CITY OF ALBUQUERQUE

**Re: Beehive at Montano
Traffic Circulation Layout**
Engineer's/Architect's Stamp dated 7-19-16 (E10-D027)

Project Title: Beehive at Montano Building Permit #: _____ City Drainage #: E10 D027
DRB#: _____ EPC#: _____ Work Order#: _____
Legal Description: Lots 0-26 through 0-31, Volcano Cliffs, Unit 1
City Address: _____

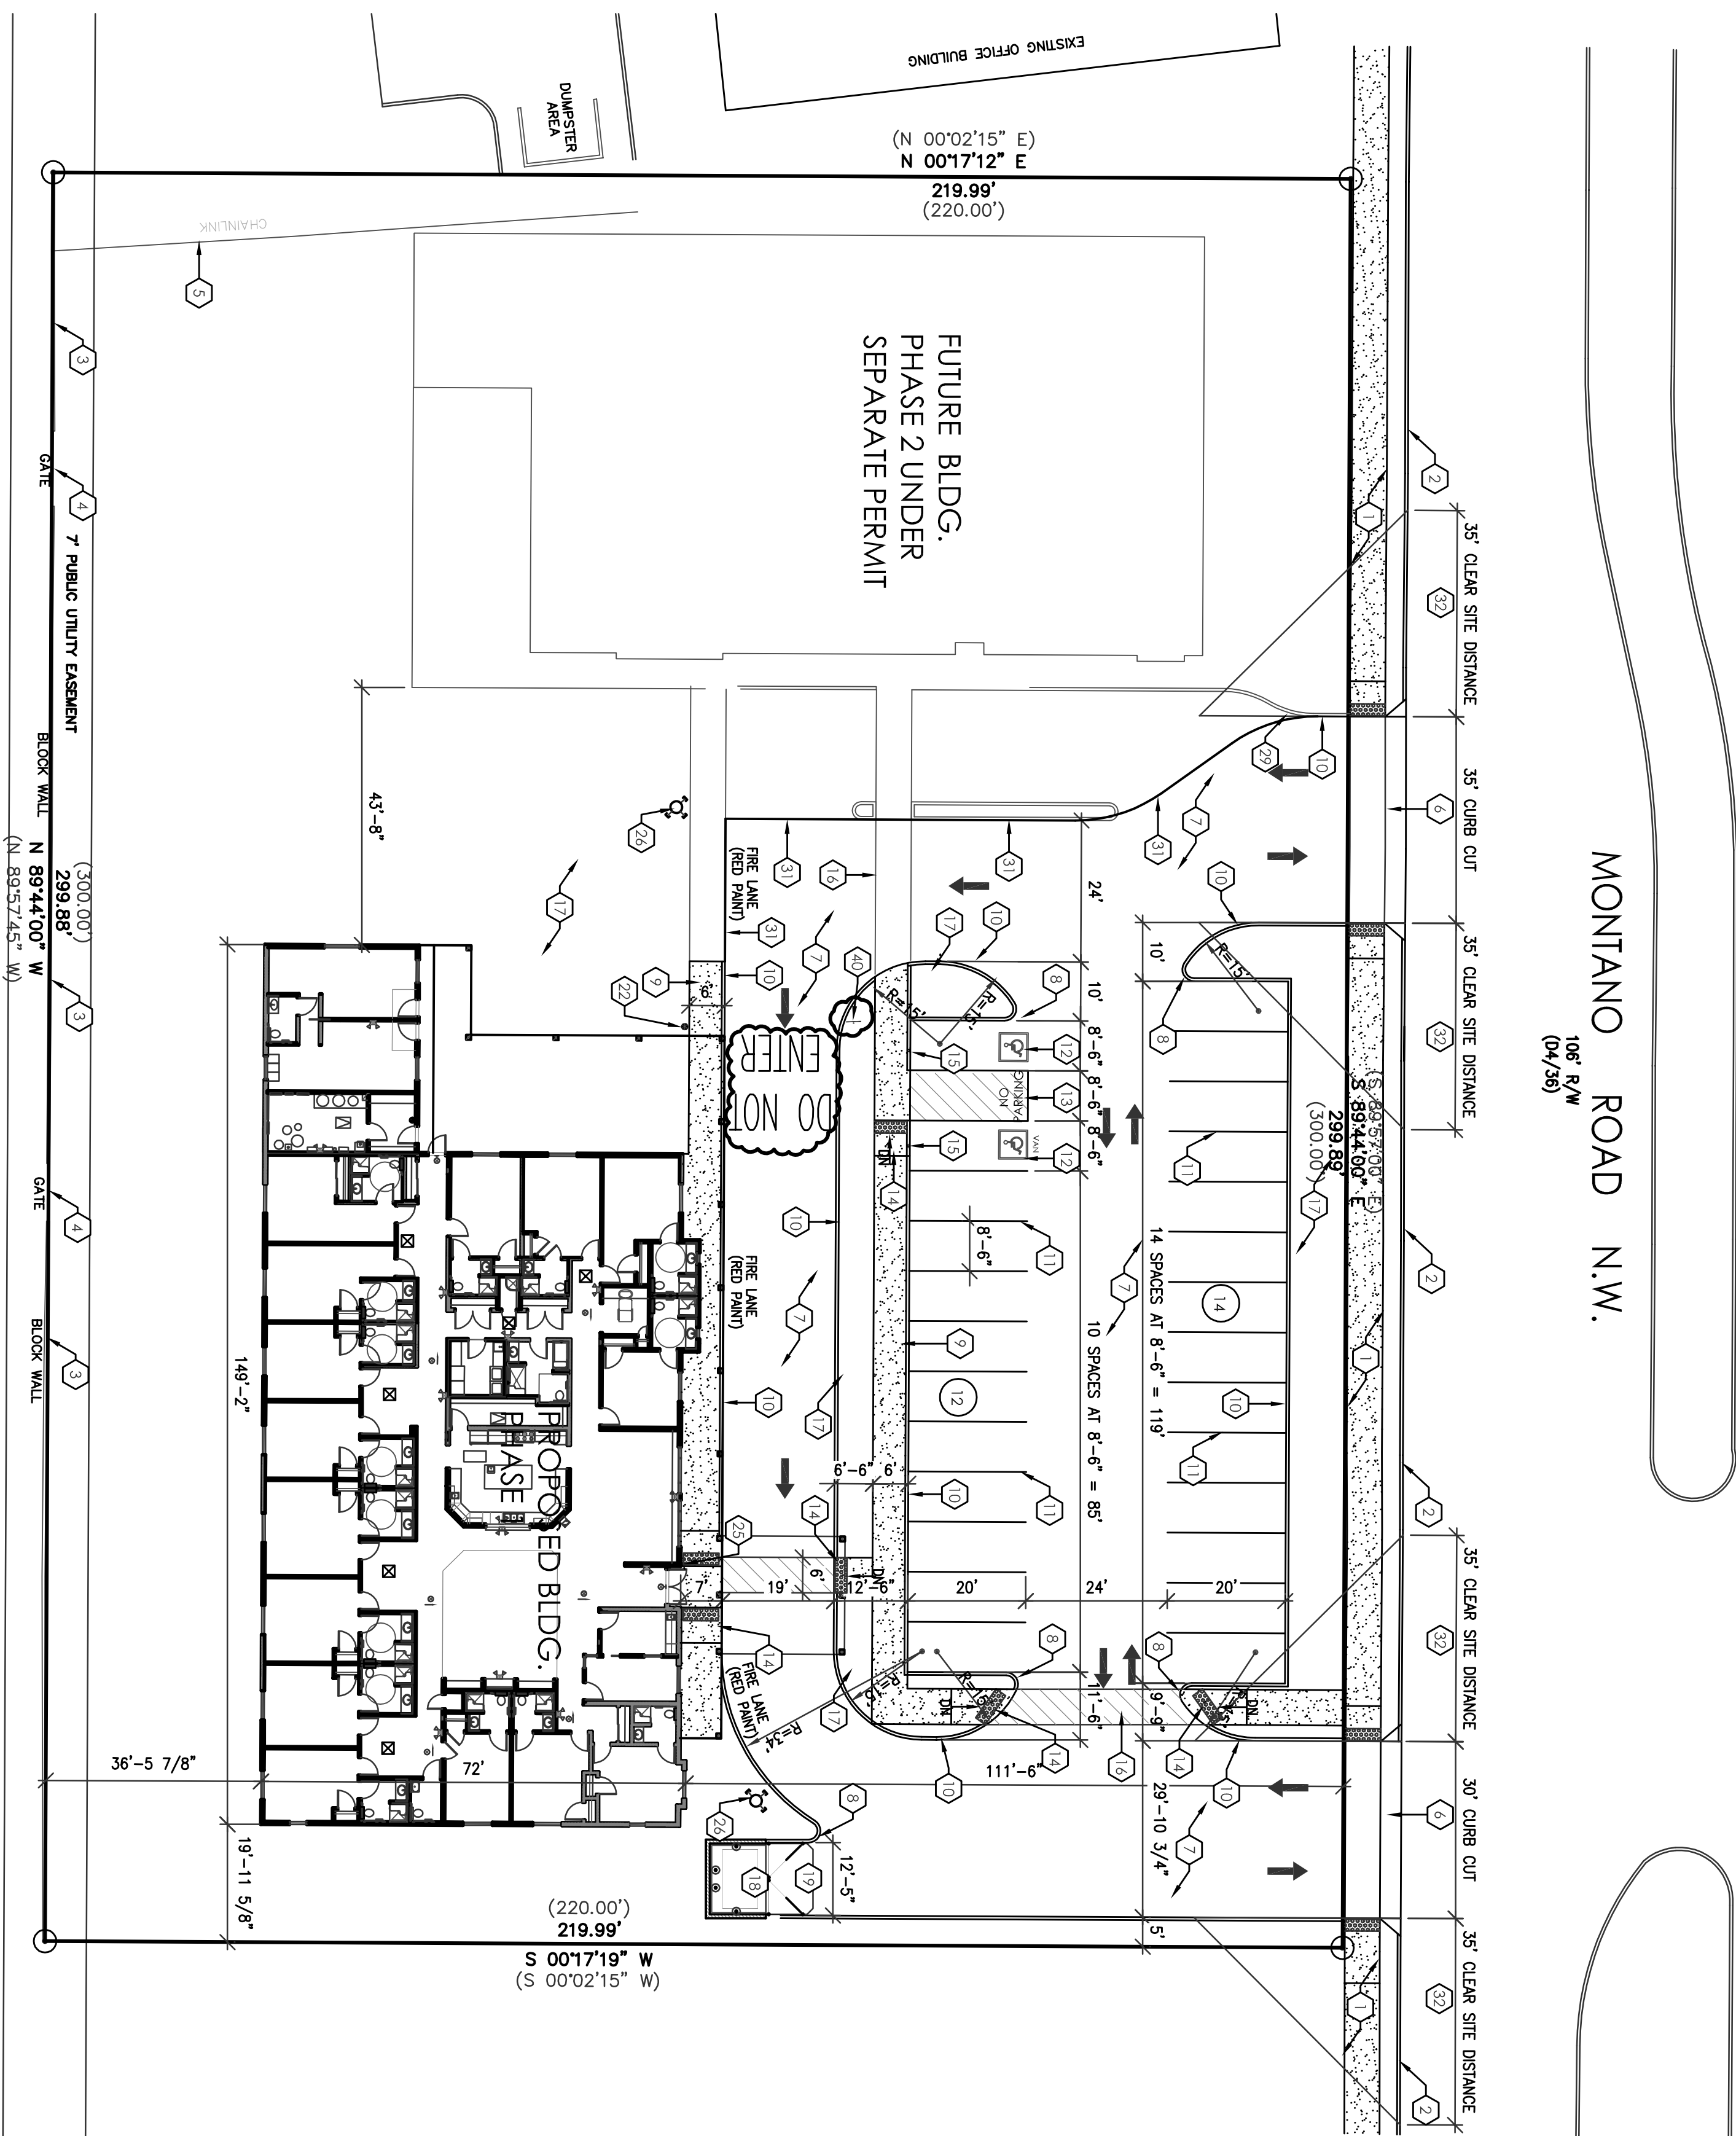
1. Please review and revise plan to align the north east curb cut on Montano Rd. to the existing medians.
2. Please include two copies of the traffic circulation layout at the next submittal.
